SUNDRY NOTICES AND REPORTS ON WELLS

er Horizontal Redrill

Merrion Oil & Gas Corporation Well Control Equipment Schematic for 2M Service

PWU No. 3 Horizontal Entrada Well

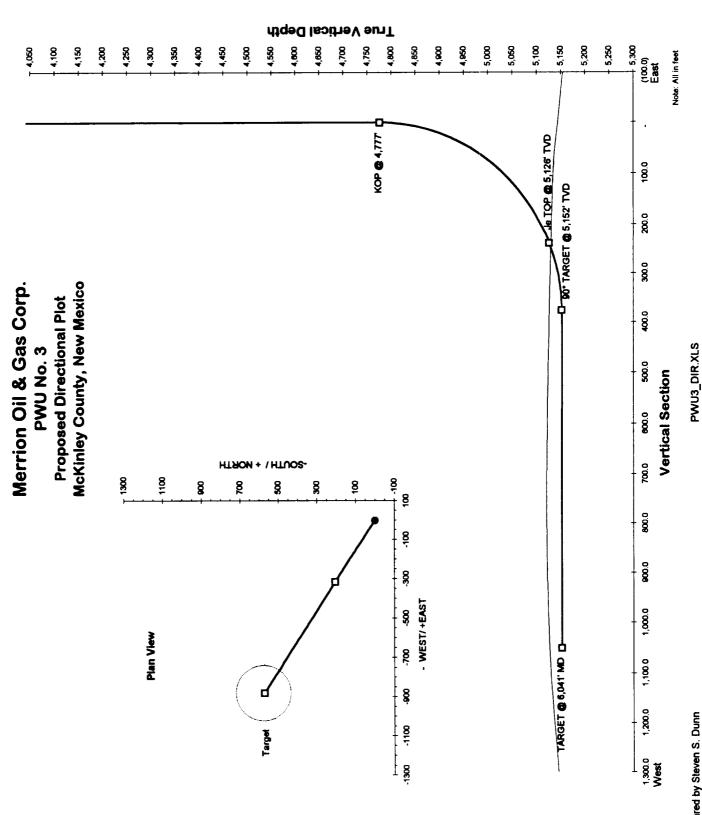
- 1. Mike Flaniken with the Farmington Office is to be notified at least 24 hours before the workover operations commence (505) 599-8907.
- 2. The following modifications to your horizontal redrill program are to be made (when applicable):
 - 1. Tag top of cement plug at 5042'.
 - 2. If a 4 1/2" liner is ran, the liner top overlap must be a minimum of 100 feet.
